PRELIMINARY DRAINAGE REPORT AND MDDP ADDENDUM
FOR
HOMESTEAD NORTH AT STERLING RANCH PRELIMINARY PLAN

February, 2021
Project No. 25188.00

PCD Filing No.:
SP-20-008

EX DRAINAGE MAP
HOMESTEAD NORTH
JOB NO. 25188.00
1–27–2021
SHEET 1 OF 1

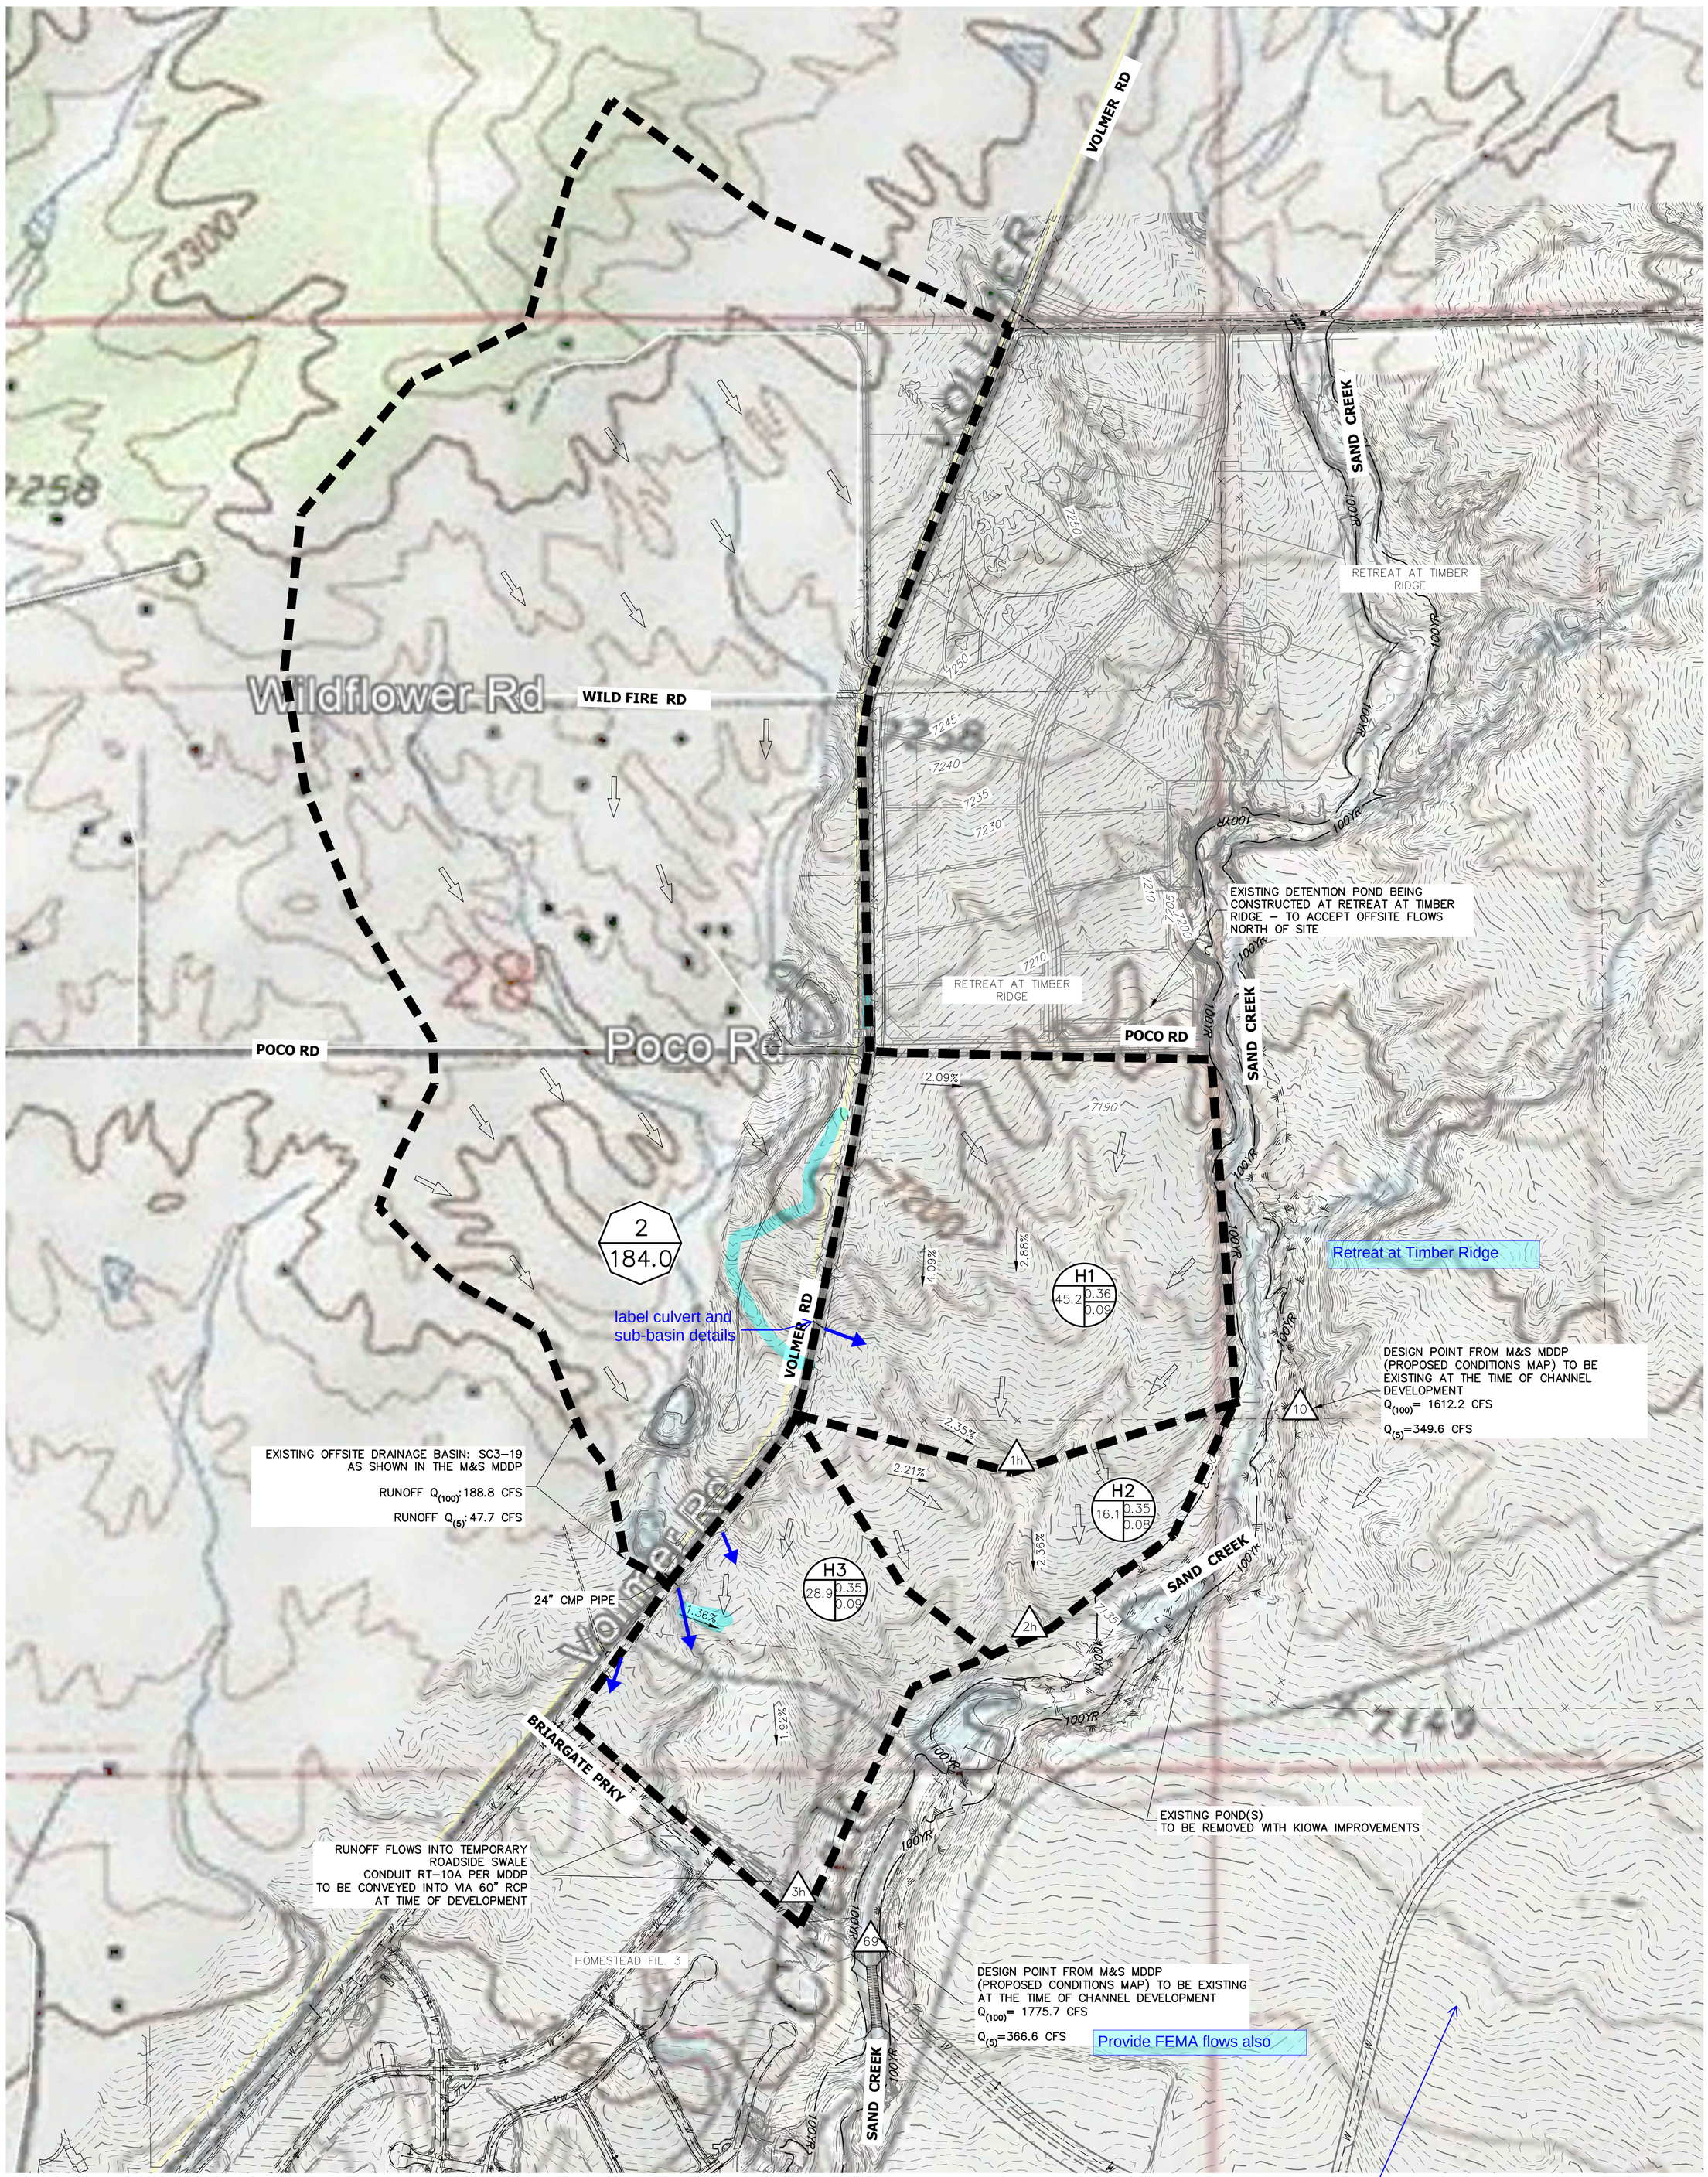
Include the area with the proposed roads or provide a separate existing plan for that area.

EARLY GRADING – DRAINAGE MAP
HOMESTEAD NORTH
JOB NO. 25188.00
02/12/21
SHEET 1 OF 1

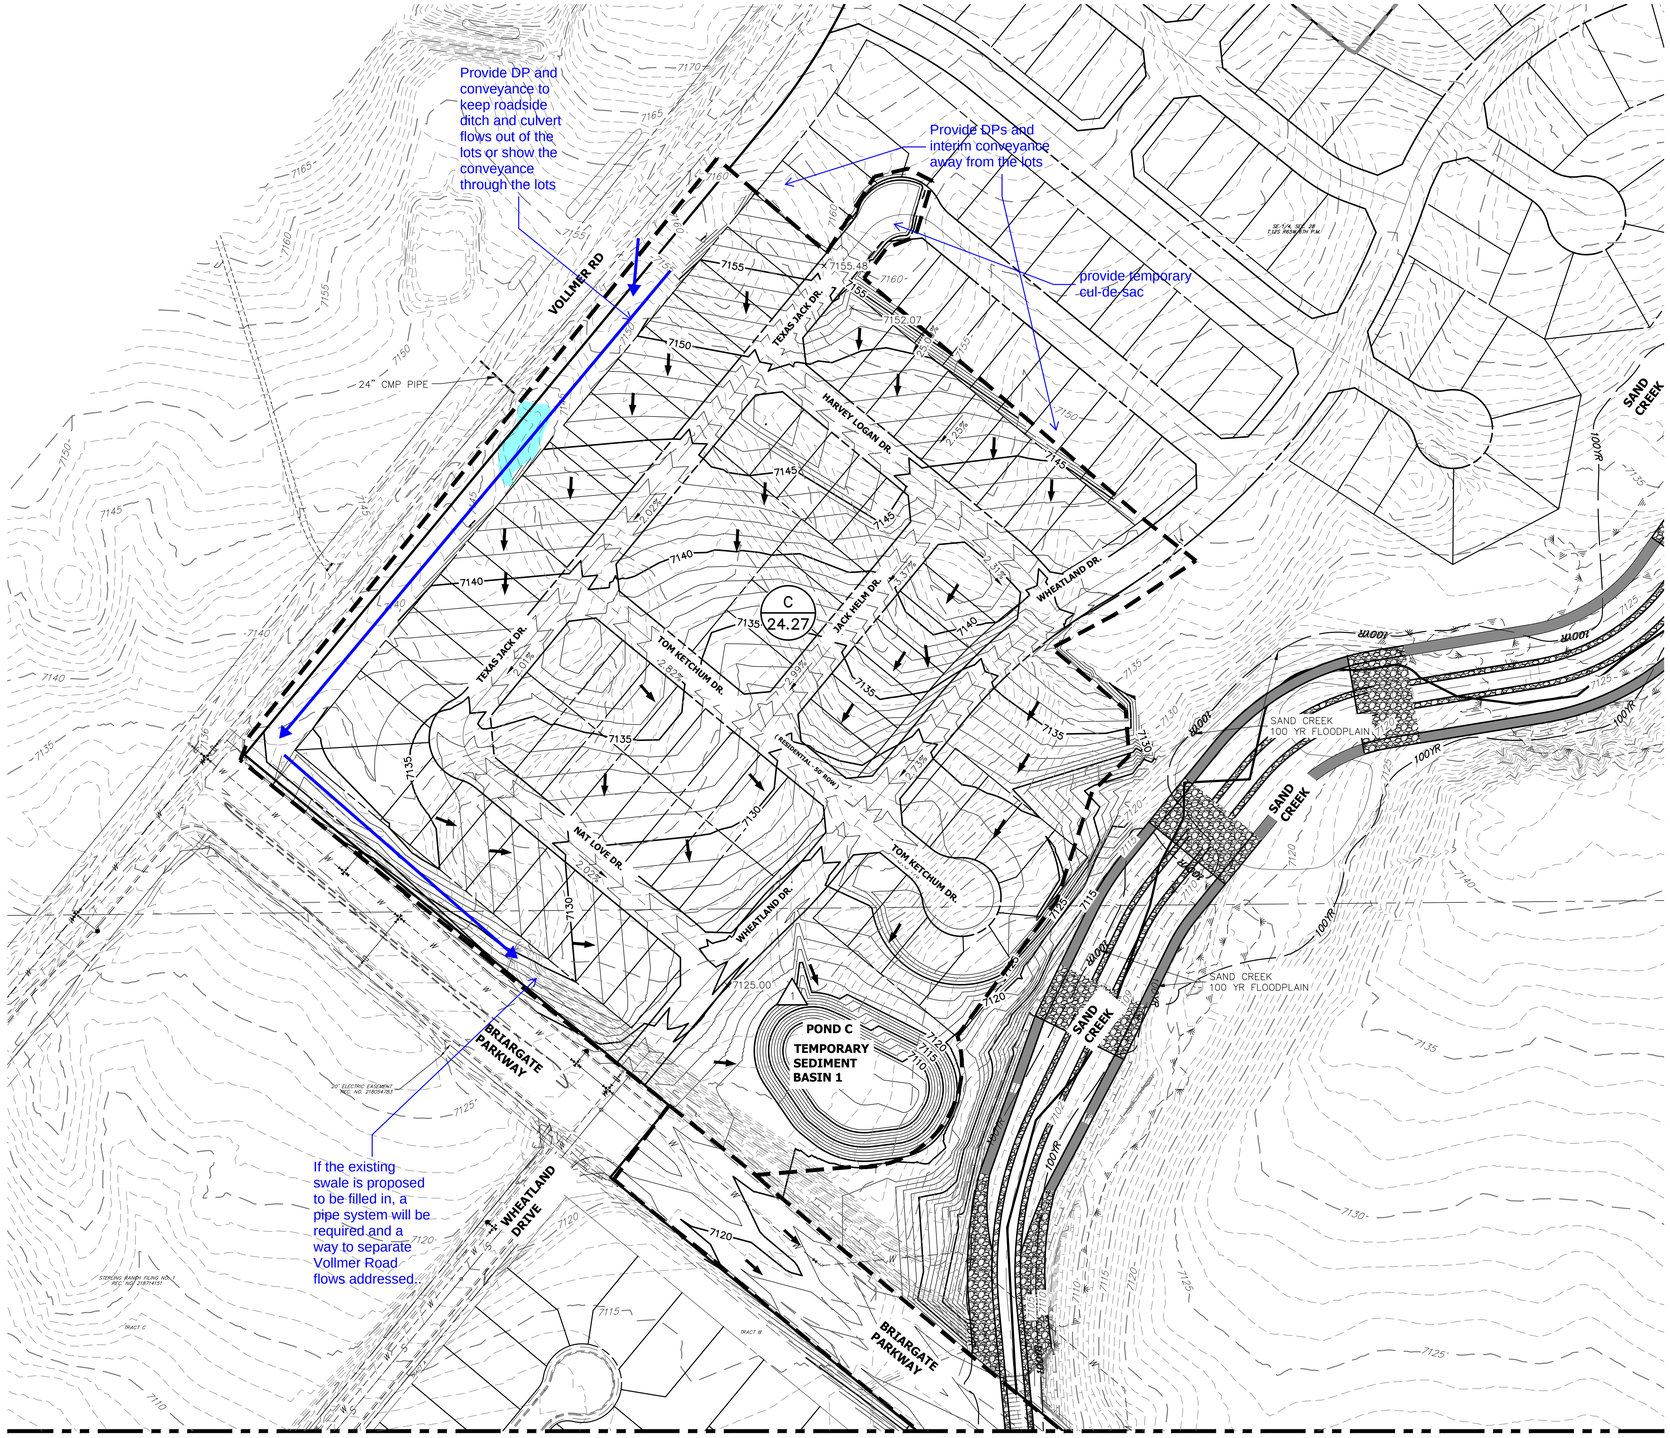
Provide basin and DP summary tables

EARLY GRADING – DRAINAGE MAP
HOMESTEAD NORTH
JOB NO. 25188.00
02/12/21
SHEET 2 OF 4

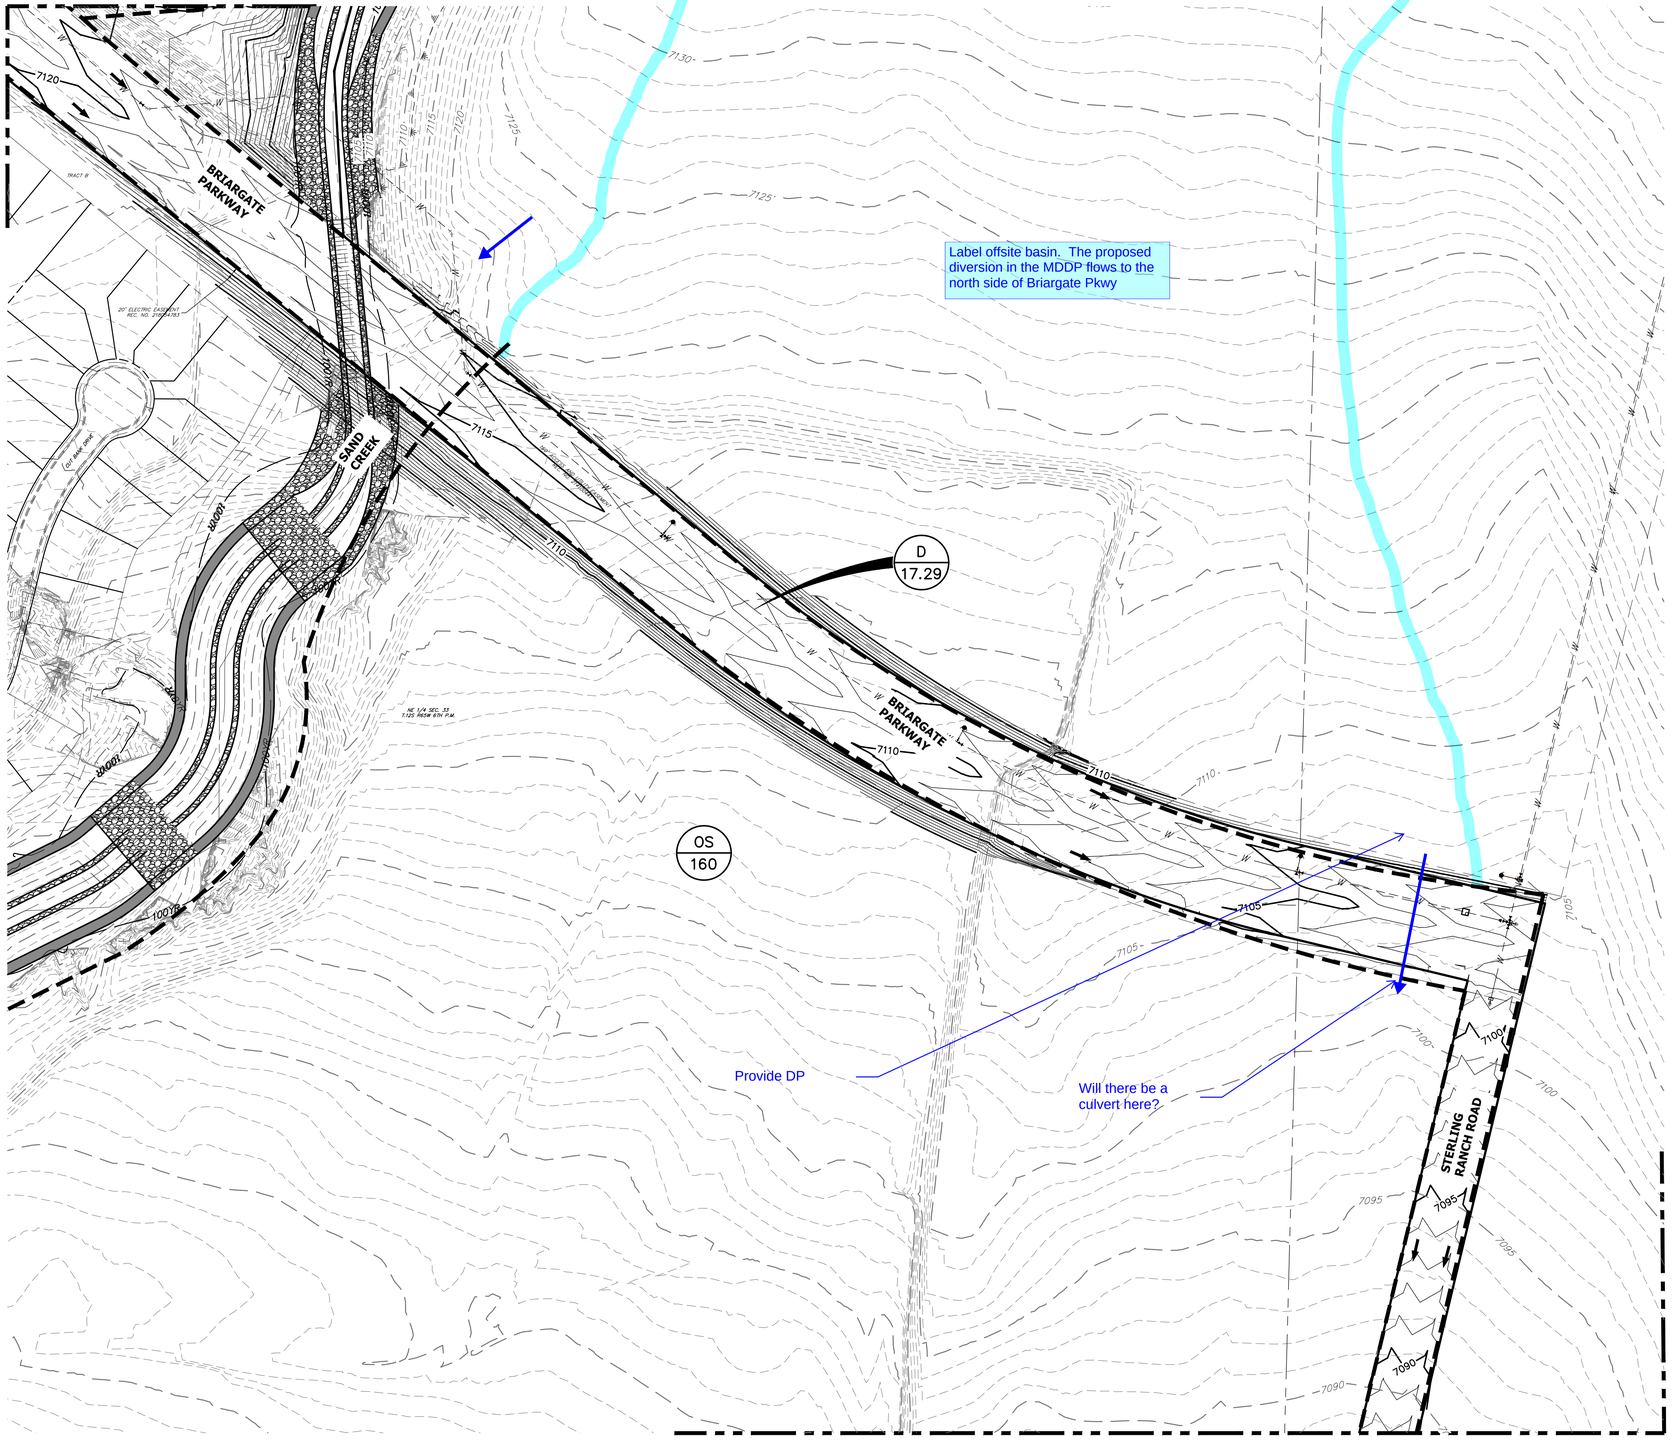
Provide basin and DP summary tables

EARLY GRADING – DRAINAGE MAP
HOMESTEAD NORTH
JOB NO. 25188.00
02/12/21
SHEET 4 OF 4

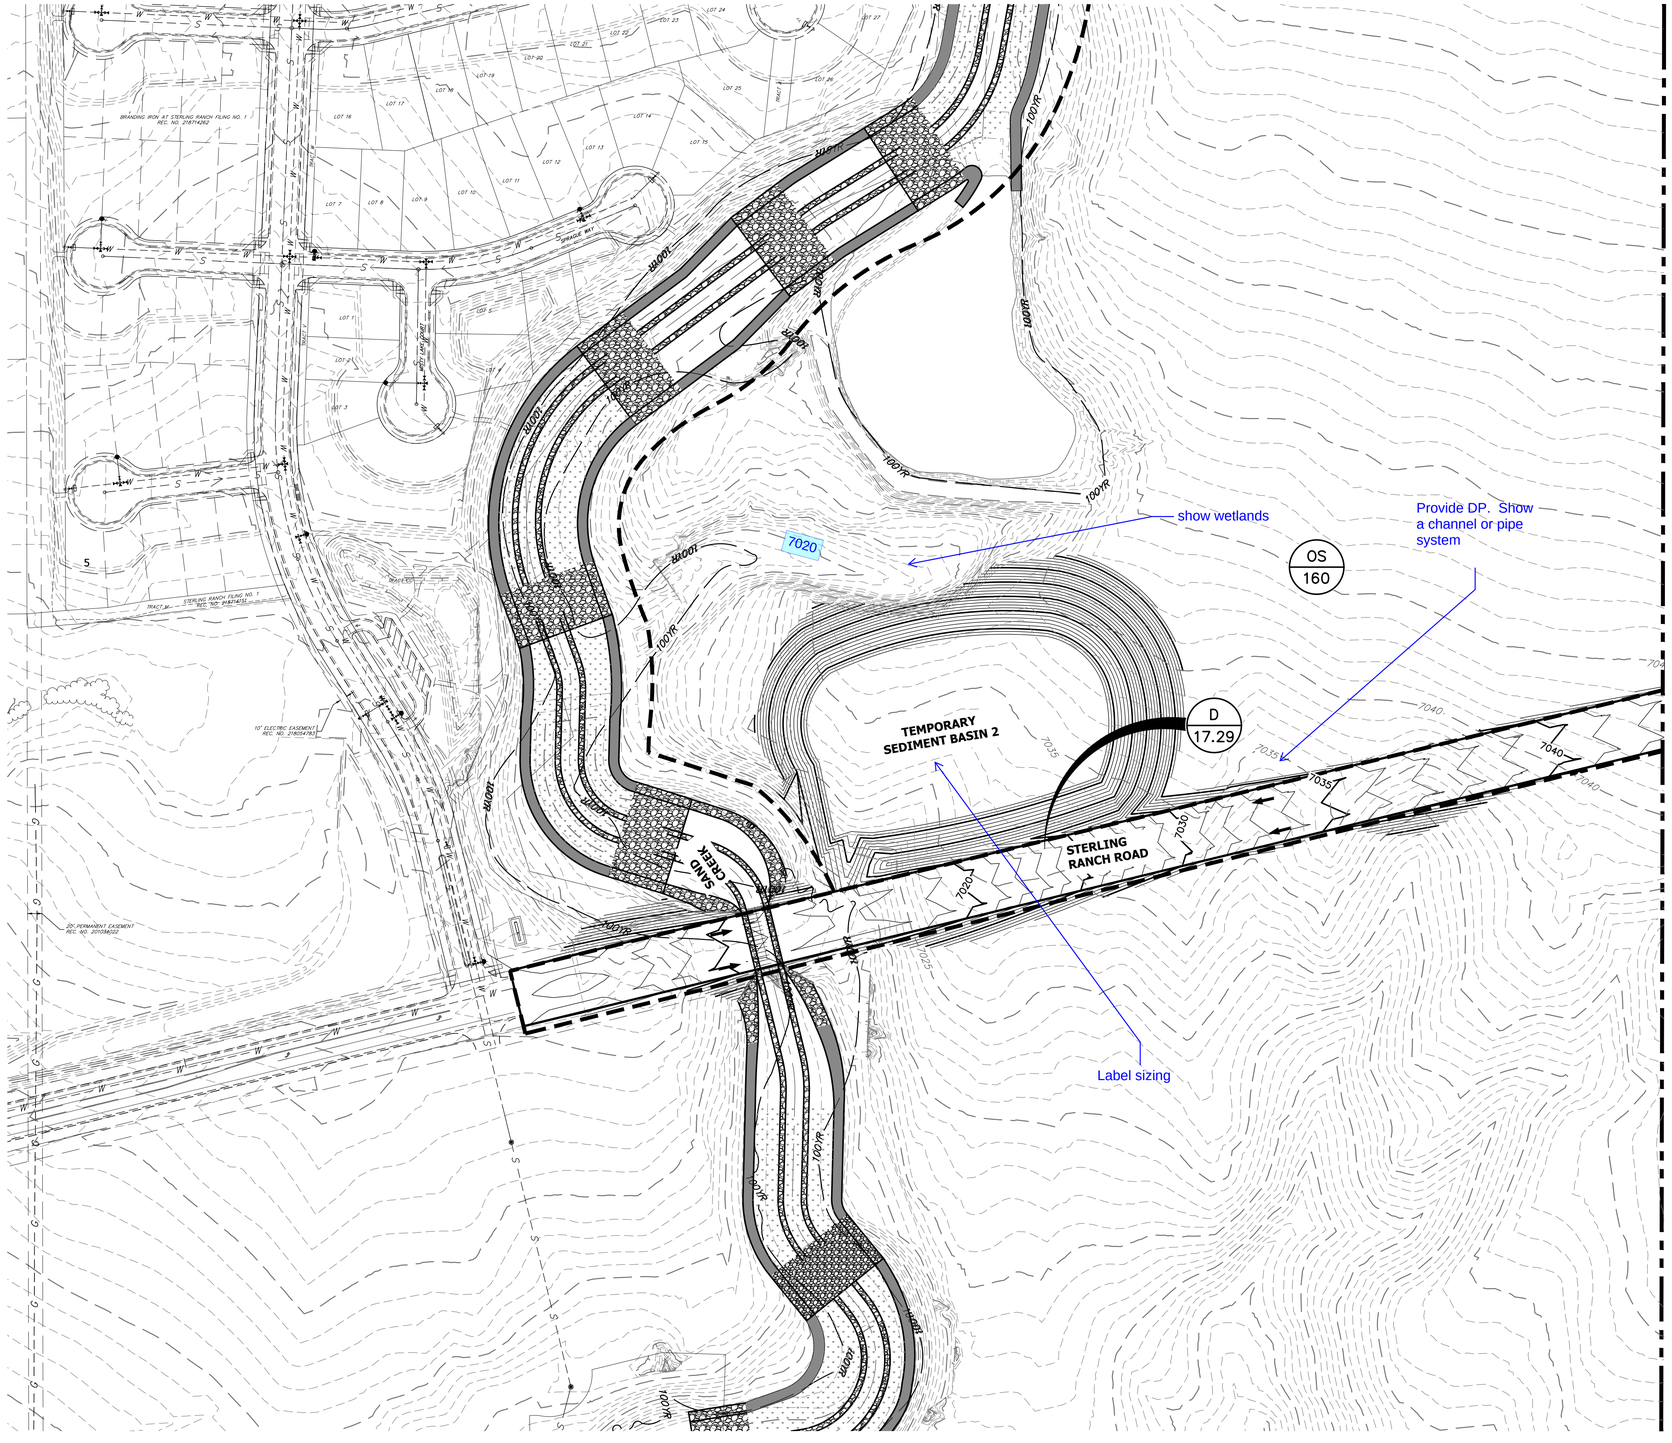
Provide basin and DP summary tables
